**MUNICIPALITY OF ANCHORAGE
MEMORANDUM**

SUBJECT: 2015-0067 Academy Drive/Vanguard Drive to Abbott Road Context Sensitive Solutions Transportation Project Site Plan Review (Plans in Hand) for Academy Drive /Vanguard Drive Area Traffic Circulation Improvements ADOT&PF and MOA Project #09-004

Background: The Office of Planning, Development and Public Works is requesting Plans In Hand review and approval of the Academy Drive/Vanguard Drive Area Traffic Circulation Improvements.

Figure 6: Proposed Typical Cross Section

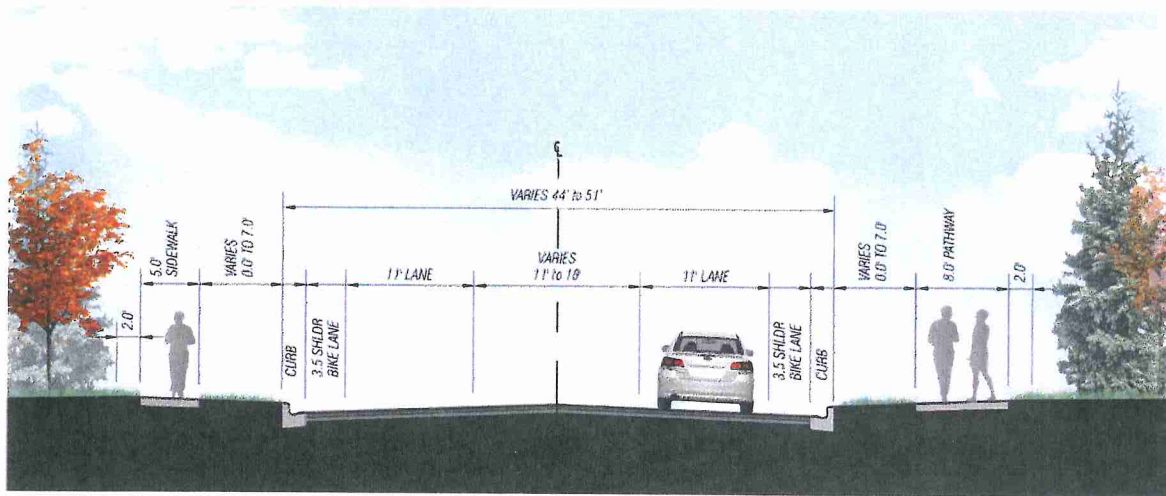
2. Transportation Planning recommends:
 - a. Add a detailed lighting site plan or delineating where said lighting fixtures will occur on the site plans in the submittal.

- d. Clearly delineate how the bike lane will transition to the shared use path along Academy Drive. Consider putting a shared bike marking on the road where right-of-way width does not allow a bike lane. The transition of the bike lane onto the shared use path can potentially cause conflicts between bicyclists and pedestrians so clear delineation of how the cyclist gets to and off the path is helpful.
